**TOWN OF NEWBURGH
PLANNING BOARD
TECHNICAL REVIEW COMMENTS**

PROJECT NAME: UNITY PLACE WAREHOUSE
PROJECT NO.: 21-29
PROJECT LOCATION: NORTHWEST CORNER OF OLD LITTLE BRITAIN RD. & UNITY WAY
SECTION 95, BLOCK 2, LOT 14.1 & 19.12
REVIEW DATE: 10 JUNE 2022
MEETING DATE: 16 JUNE 2022
PROJECT REPRESENTATIVE: BROOKER ENGINEERING

Unity Place Warehouse
Town of Newburgh Planning Board Application for Site Plan Approval
Narrative Summary, Responses to Comments, and Correspondence
June 7, 2022
BE #21202

FLARED END SECTION DETAIL
N.T.S.

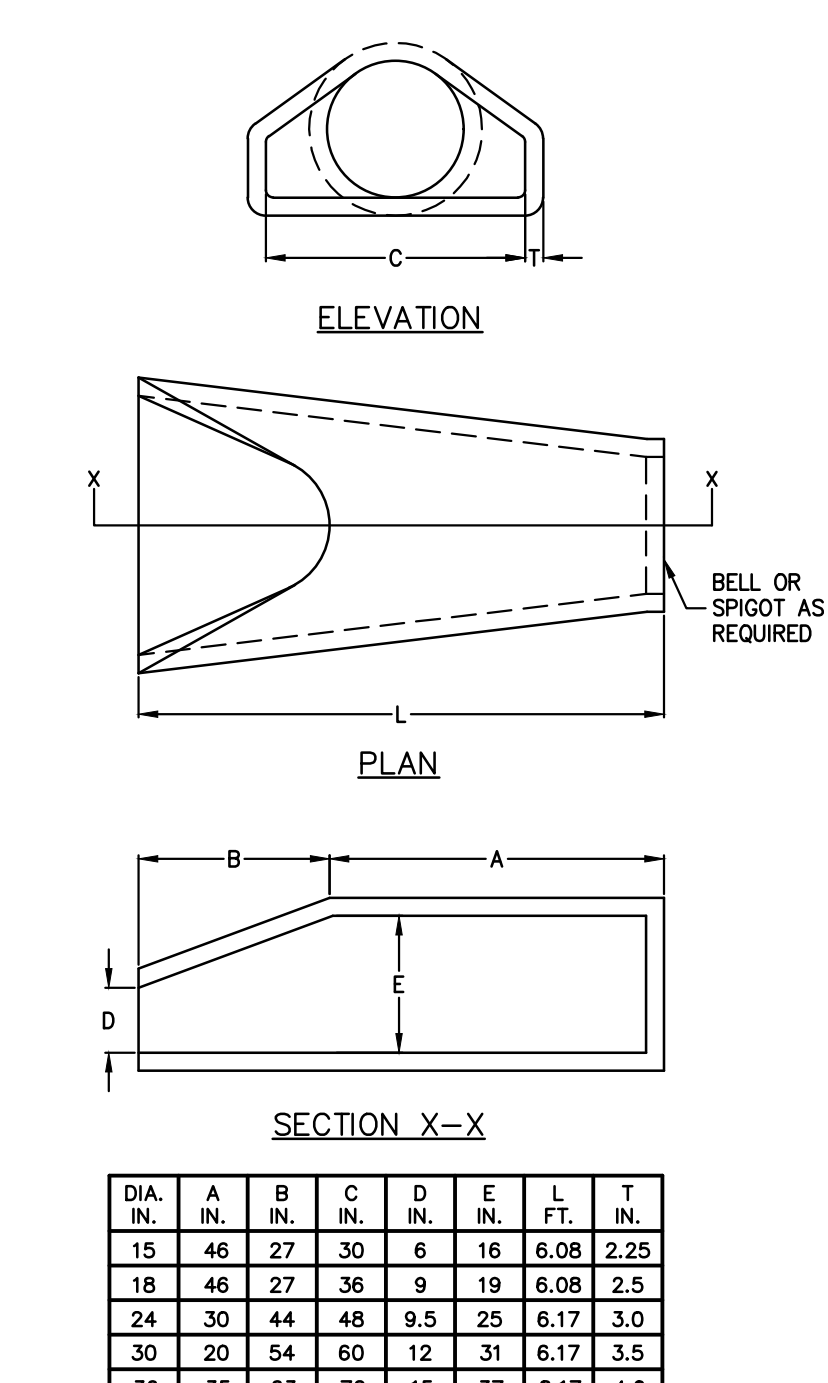
9. The applicant's representative is requested to identify a location where flared end section 15 discharges to a natural water course. Currently that discharge will be at a point along an adjoining property line.
